**RE: Subgrade Inspection for Lot # 135 Hawthorne Ridge – 3104 SW Arbortree Dr
Lee's Summit, MO 64082 – Permit # PRRES20214077**

On September 9, 2021, a special inspection was performed by Everstead at the above referenced property. The purpose of this inspection was to determine structural adequacy of the existing soil for construction of concrete foundation.

SPREAD FOOTING
DETAIL
N.T.S.

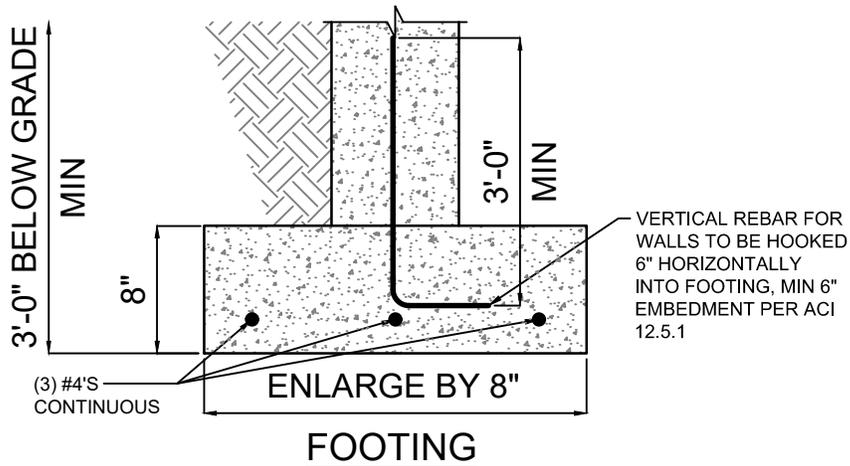
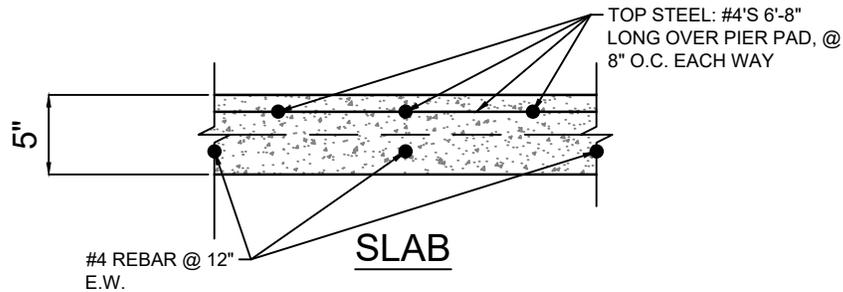
- The soils observed at footing elevation were silty clay; light-medium brown; medium plasticity and moist with what appears to be fill at the rear of the lot.
- Probes and penetrometer readings indicated that the soils do not have sufficient bearing capacity for the loads applied by foundation per permit plans.

- Everstead recommends that the footings be enlarged to 24"x8" with three (3) #4 rebar continuous (see attached specifications), also that the footing elevation at the rear of the lot be extended down past the fill and topsoil to bear directly on natural, competent clay material.
- Basement and garage pier pads shall be enlarged a minimum of 6" each way (i.e existing 30"x30" shall be enlarged to 36"x36", etc.) (see attached specifications)
- Footings at the rear of the lot may need to vary in elevation based on exact location and depth of clay.
